United States Patent and Trademark Office

APPLICATION NO.	FILING DATE	FIRST NAMED INVENTOR	ATTORNEY DOCKET NO.	CONFIRMATION NO.	
10/767,211	01/28/2004	Frederick J. Dojan	005127.00275	2584	
22909	7590 03/27/2006	•	EXAM	EXAMINER	
BANNER & WITCOFF, LTD. 1001 G STREET, N.W.			KAVANAUGH, JOHN T		
	ΓON, DC 20001-4597		. ART UNIT	PAPER NUMBER	
	·		3728		
			DATE MAILED: 03/27/2000	DATE MAILED: 03/27/2006

Application No.	Applicant(s)				
Office Action Comments		10/767,211	DOJAN ET AL.				
	Office Action Summary	Examiner	Art Unit				
		Ted Kavanaugh	3728				
Period fo	The MAILING DATE of this communication a or Reply	ppears on the cover sheet with the	correspondence addres	ss			
A SHORTENED STATUTORY PERIOD FOR REPLY IS SET TO EXPIRE 3 MONTH(S) OR THIRTY (30) DAYS, WHICHEVER IS LONGER, FROM THE MAILING DATE OF THIS COMMUNICATION. - Extensions of time may be available under the provisions of 37 CFR 1.136(a). In no event, however, may a reply be timely filed after SIX (6) MONTHS from the mailing date of this communication. - If NO period for reply is specified above, the maximum statutory period will apply and will expire SIX (6) MONTHS from the mailing date of this communication. - Failure

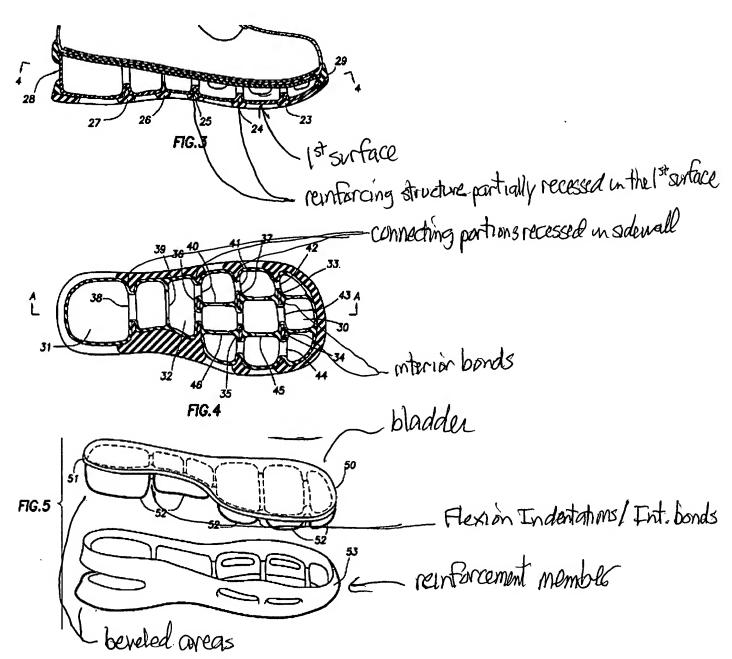
3. Claims 51-56,61-64,116 are rejected under 35 U.S.C. 102(b) as being anticipated by US 6009637 (Pavone).

Pavone teaches an article of footwear comprising an upper and a sole structure as claimed; see the marked-up figures below. a sole component as claimed including a bladder and a reinforcing structure at least partially recessed into the barrier material as claimed. See the marked-up figures below. When the bladder is inflated (see col. 2, lines 60-67) to a desired pressure it will inherently place the connecting portions of the reinforcing structure in tension assuming the pressure is greater than atmospheric pressure.
